Re: Wellesley Country Club Redevelopment – Peer Review

Job # 3016 - 14

As part of the Wellesley Country Club (WCC) redevelopment, BETA Group, Inc. has received Vanasse Hangen Brustlin, Inc.'s (VHB) memorandum dated June 6, 2006. This memorandum is VHB's response to BETA's peer review dated April 24, 2006. For ease of reference our response (in bold letters) to each comment follows the format of the VHB response letter.

Sidewalk Analysis

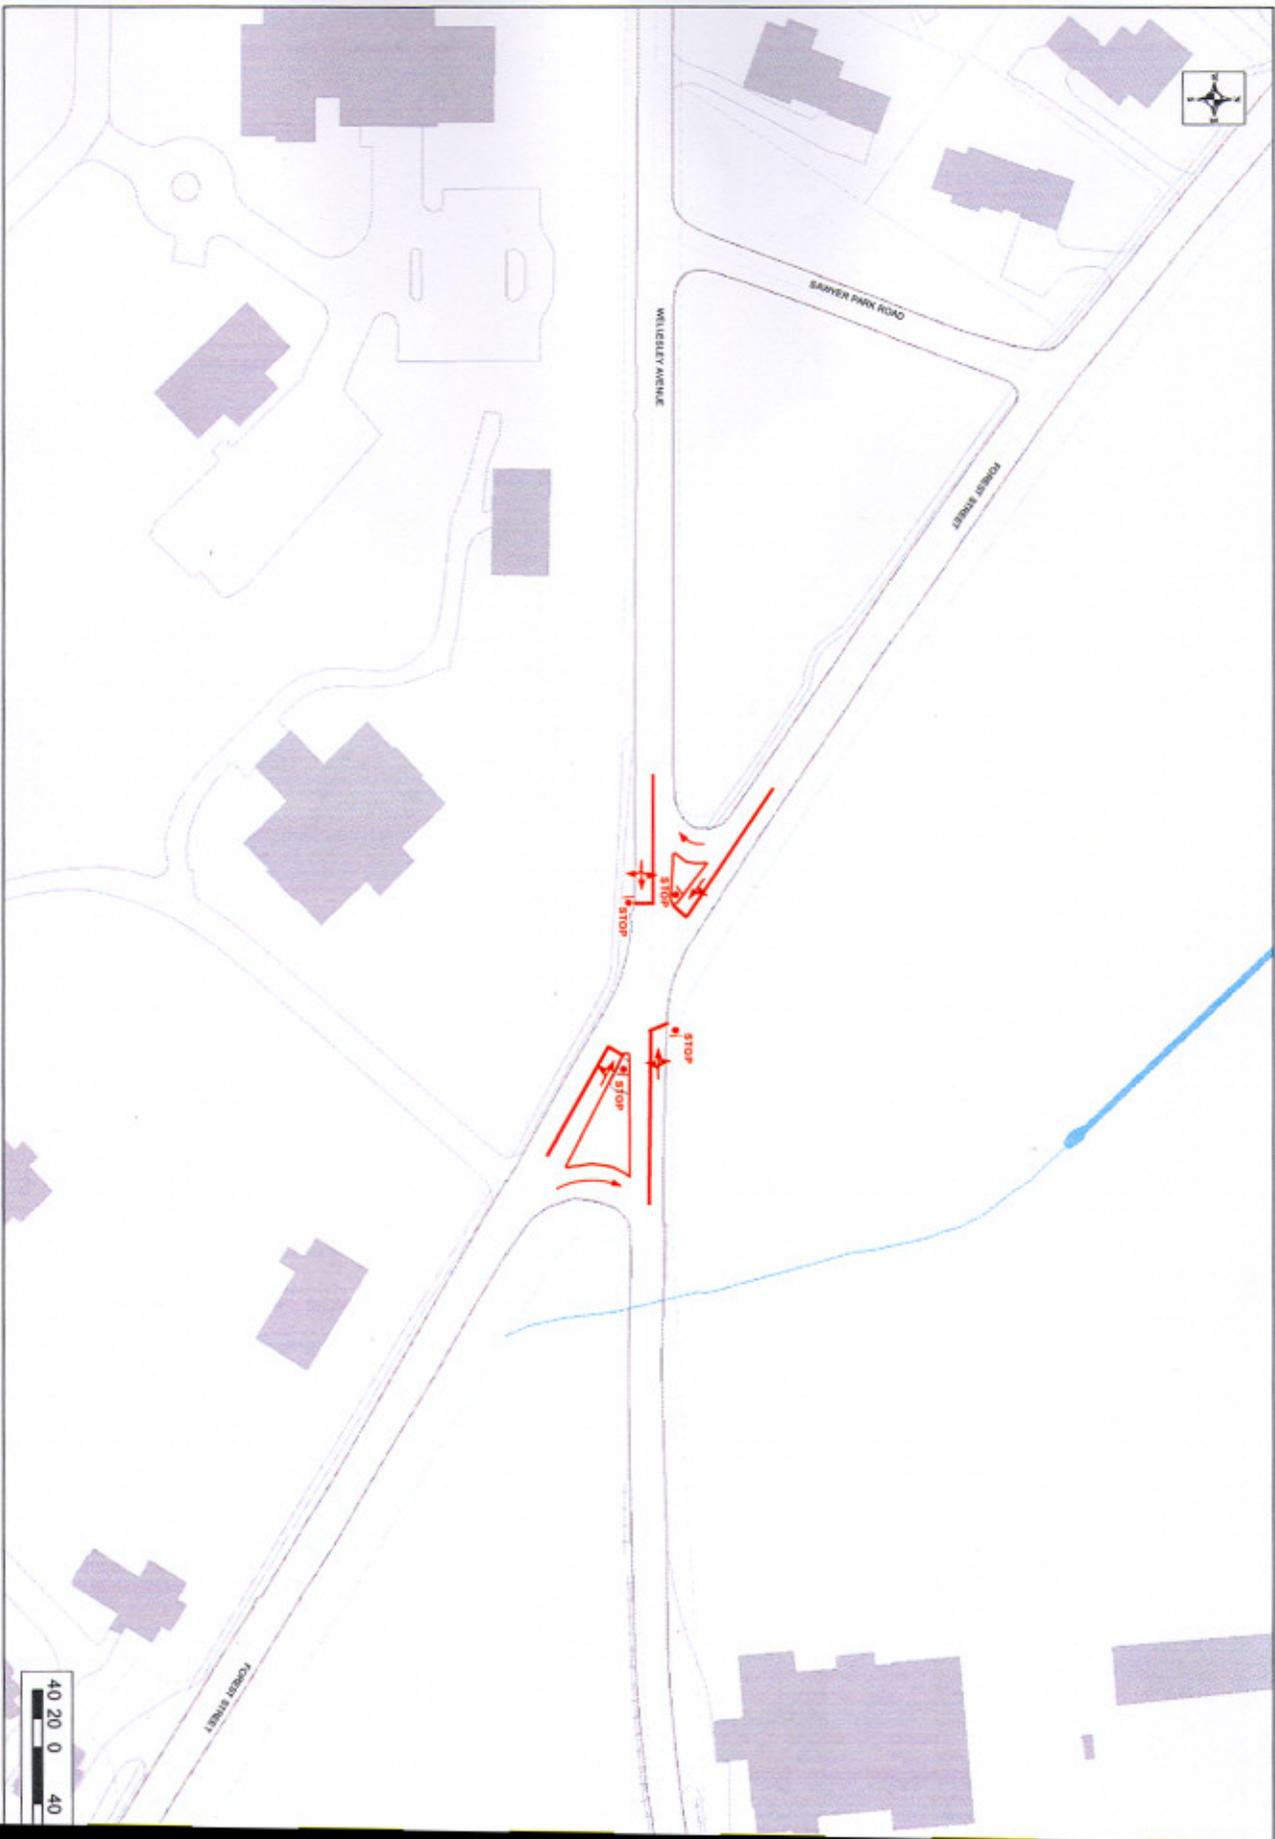
As required by the Wellesley zoning bylaws, a sidewalk inventory on roadways within a walking distance of 600 feet from the WCC needs to be performed. VHB included this inventory within the June 6, 2006 memorandum.

- According to the Town of Wellesley Trail Committee, a sidewalk between the aqueduct trail and the Forest Street/Wellesley Avenue intersection should be considered.
- Based on our field investigation it is confirmed that the sidewalk condition along Forest Street between Wellesley Avenue and Abbott Road is fair to good. A proposed sidewalk improvement plan should be developed for this area.
